SAFETY EVALUATION REPORT
MODIFICATIONS TO THE BOILING WATER REACTOR (BWR) EMERGENCY PROCEDURE
GUIDELINES TO ADDRESS REACTOR CORE INSTABILITIES

Staff Evaluation of BWROG Response to Draft Safety Evaluation of Proposed EPG Modifications

Figure A.1 Effect of Collapsed Level on Core Thermal Power

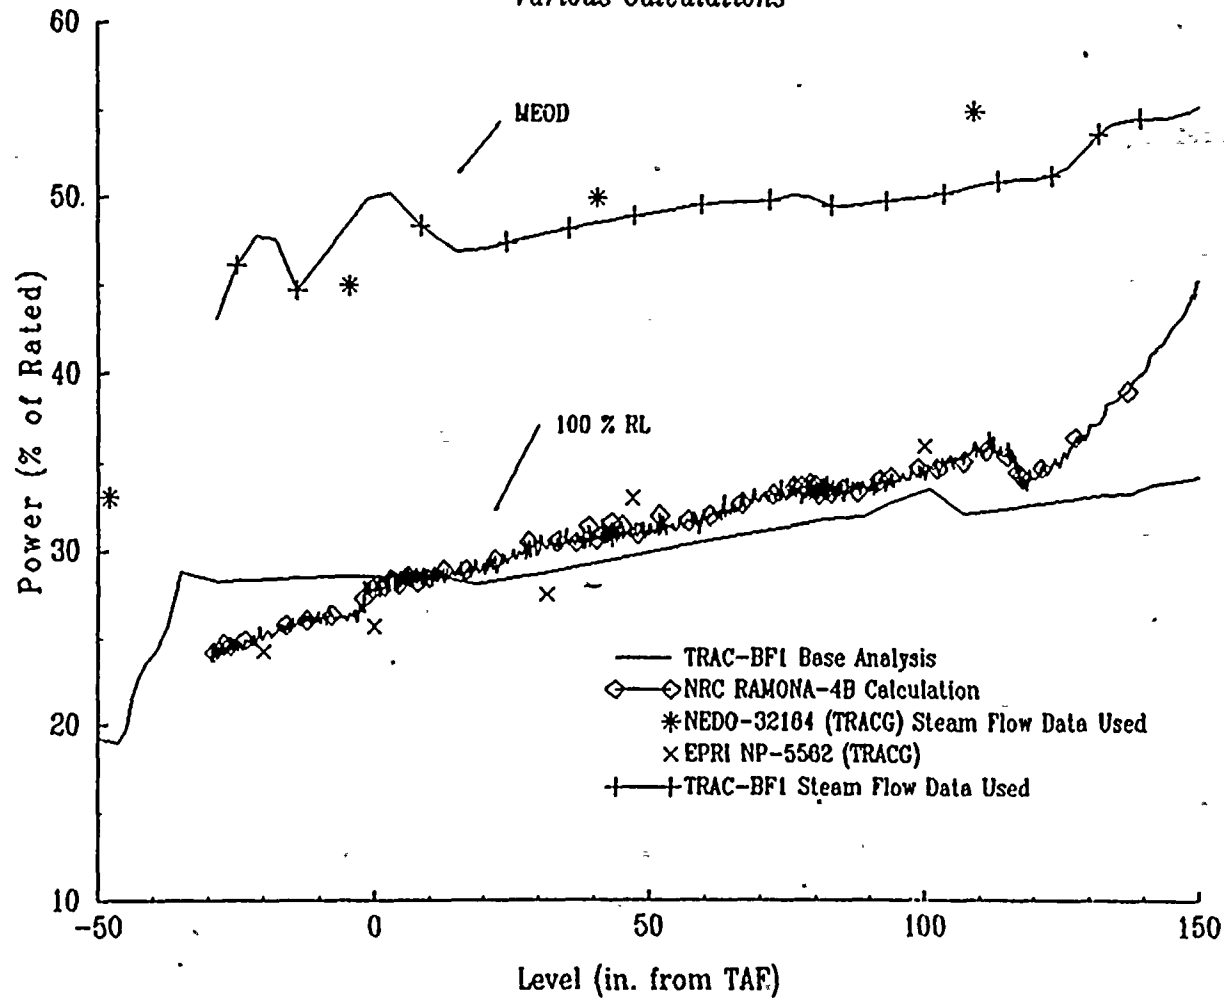
The data from these sources were used to produce Figure A.1 which plots the power as a function of collapsed level. With the exception of the TER results, the staff interpolated core power levels from published plots. For the NEDO-32164 results, the staff used the values for the vessel steam flow and, after accounting for condensation affects in the presence of cold feedwater, determined a reactor power level. This was necessary because the calculation involved an instability and the power level was impossible to determine accurately. Brookhaven National Lab performed additional calculations with RAMONA-4B and the staff completed numerous TRAC-BF1 sensitivity calculations that are not specifically reported here. All of these sensitivity studies show the same trend as the data plotted in Figure A.1.

Once the power vs. level data were gathered, the staff assumed a downcomer level as a function of time consistent with the TER results and calculated the suppression pool response. It is necessary to account for the heat generation during the initial phases of the transient because merely starting with the level at its target does not account for the initial pool temperature rise (refer to TER Figure 1). Without this initial rapid increase, the time to heat capacity temperature limit (HCTL) and margin at HCTL are incorrectly calculated. This error arises because the temperature rises at a different slope, depending on where the reactor level is, and longer times to HCTL tend to exaggerate the margin between the two strategies.

The results of the suppression pool calculation are presented in Table A.1. As can be seen, the TER results compare well with NEDO-32164 results; the SABRE results show an additional 5 minutes of margin; and EPRI NP-5562 results show an additional 3 minutes of margin. The conclusion that the staff draws from these results is that there remains a great deal of uncertainty in the calculated time to HCTL because of differences in codes and analytical assumptions. Furthermore, the additional time gained at low level is not significant enough to procedurally account for the low probability event of an SLC system failure due to the adverse impact on the higher probability SLC operable event. In other words, the staff
